FILE No. TP/99/0733

Project: **CAMPDEN HILL RESERVOIR**

MINOR AMENDMENTS TO FENESTRATION, HOUSES, CAMPDEN HILL RESERVOIR.

**Town & Country Planning Act 1990
Campden Hill Reservoir Site**

FANLIGHTS
OMITTED

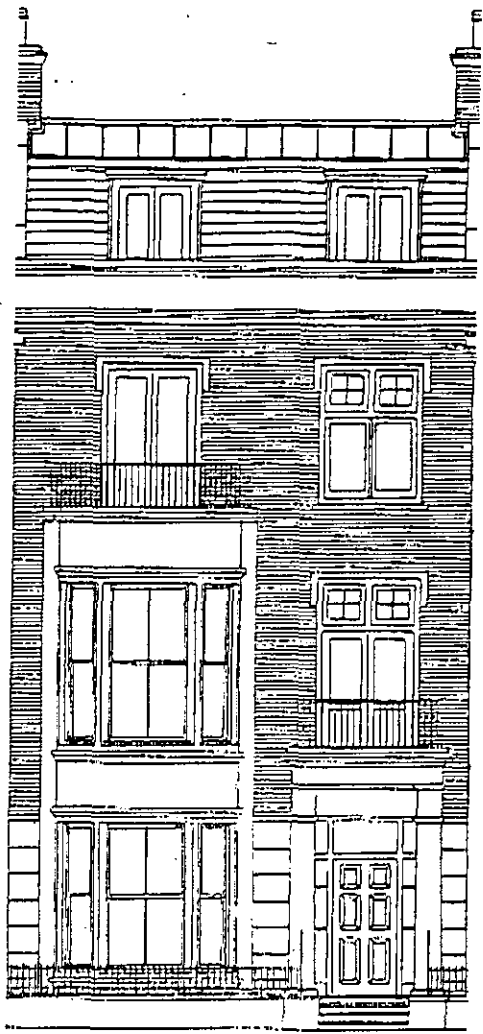
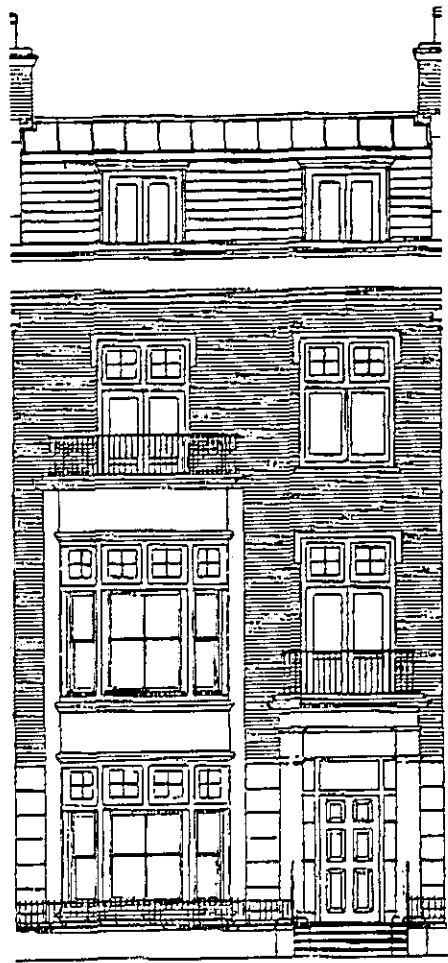
Further to our conversation this morning, please find attached two front elevation drawings for a typical terraced house at the above, one as permitted and one marked-up to show the design adjustments that we wish to make.

Principally these concern the omission of the 'fanlight' windows over bay windows and balcony doors, this elongates the proportions of the facade making it more elegant, which we consider to be a design improvement.

I can confirm that the omission of the fanlights above the curved bay windows and balcony doors as shown on your drawing numbers P103F, P104E, P105E, P108F, and P109E can be treated as a non material amendment to the scheme granted planning permission on 14 October 1999.

Plans
approved
under
appeal

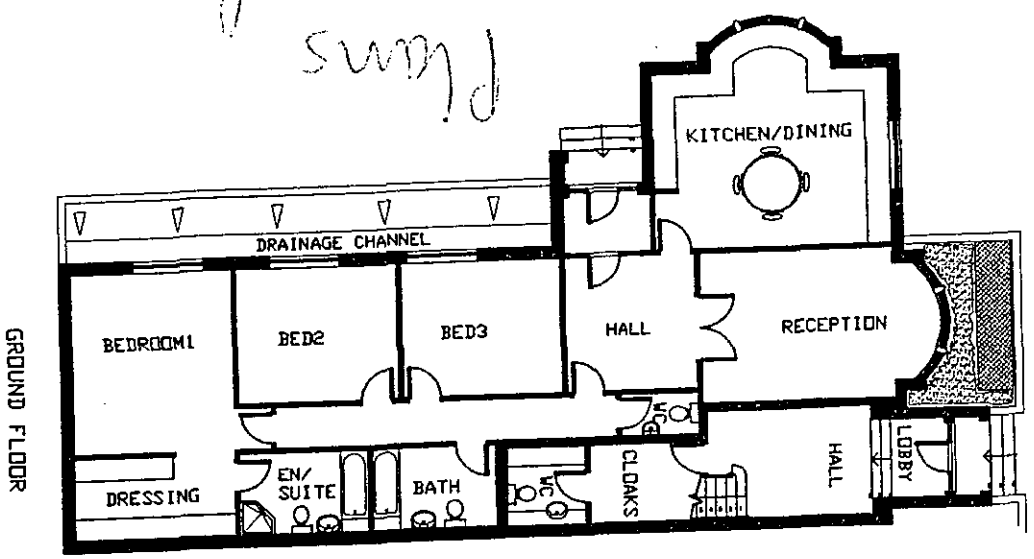
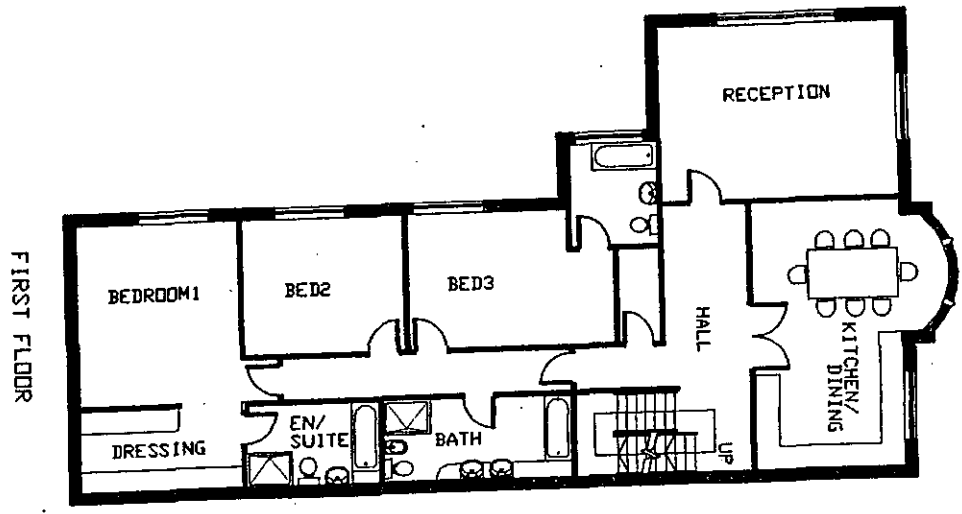
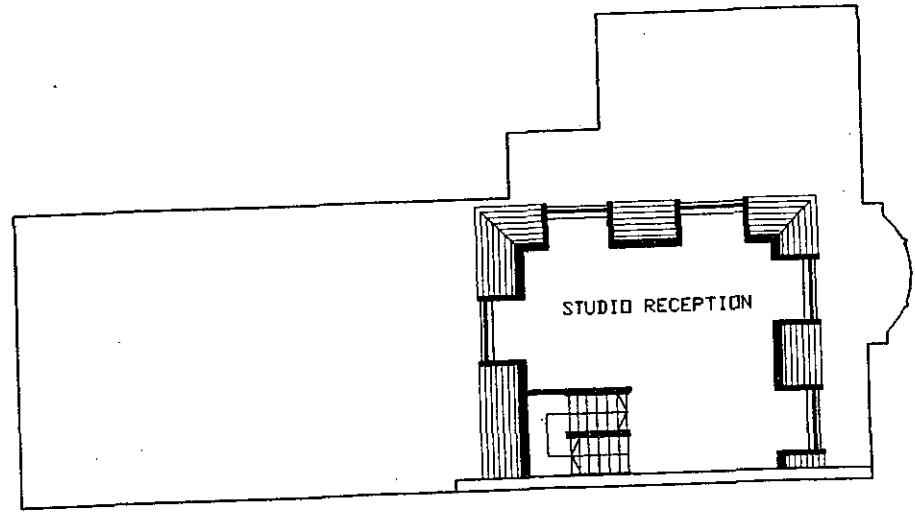
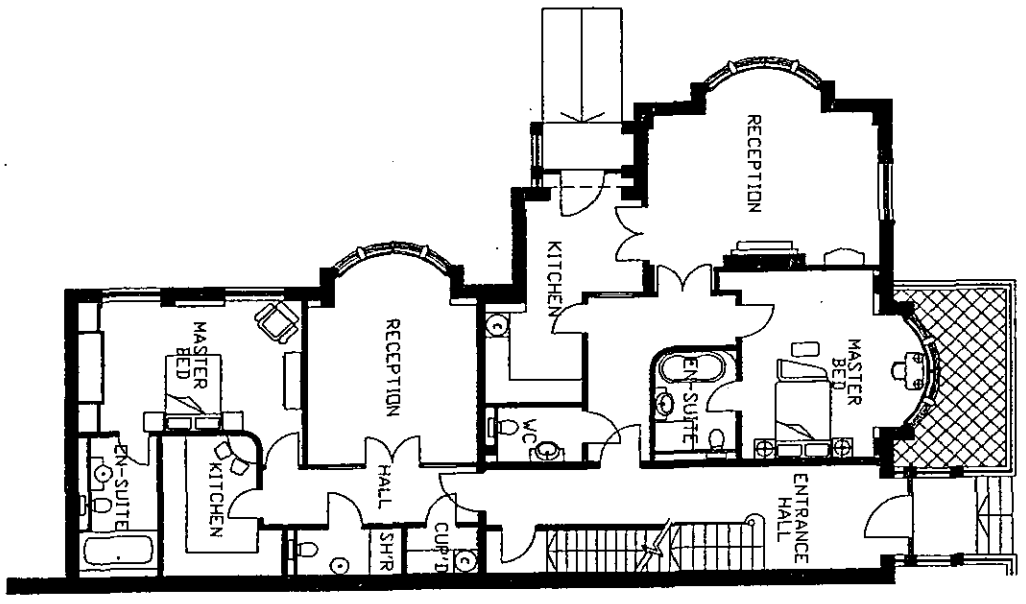
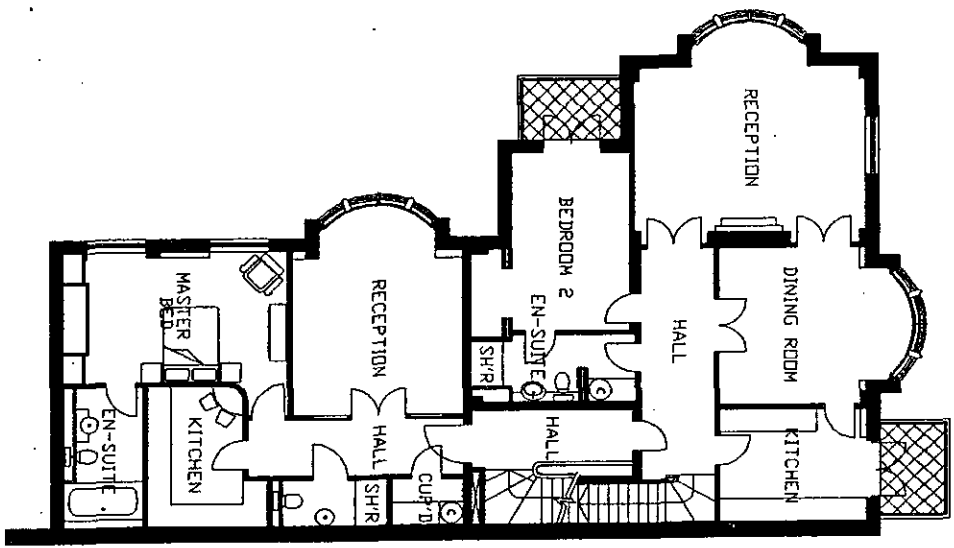
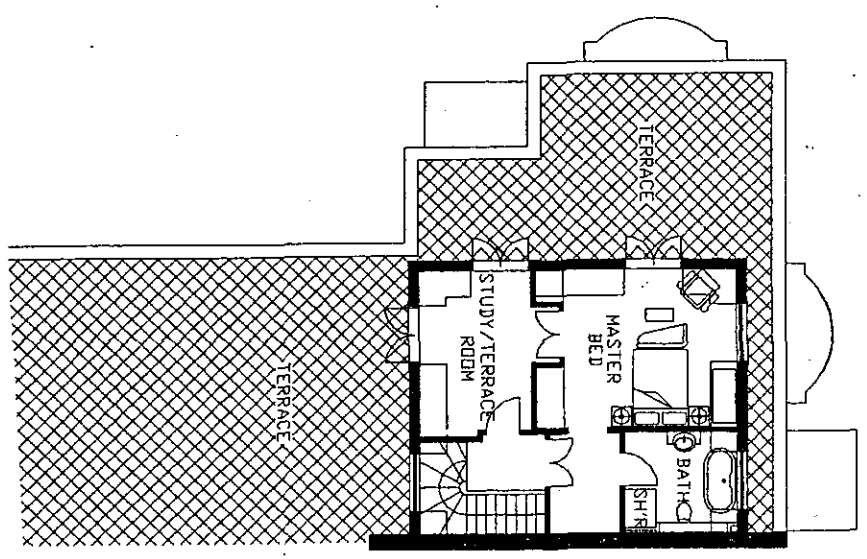
The new plans indicate the introduction of slightly wider windows and new bays to the North elevation, South terrace, new windows to the South elevation, South terrace, an orangery type glazed extension to the side of the house at the western end to the South terrace, and revised internal arrangements to the South terrace. The materials for the glazed extension are not confirmed on the plans, however the planning requirement is for a timber frame with glazed roof.

Further to our recent correspondence regarding the two bay windows in the northern block of the above site, I have enclosed a copy of the plan as approved and a plan showing the building as proposed to be adapted following the changes. I have also enclosed a copy of the letter which was sent to the developers agreeing that the changes were non-material.

I confirm that, subject to confirmation of the materials for the glazed extension, these revisions can be treated as non-material amendments to the development approved on appeal, ref. PP/99/0733, and will not require further planning permission.
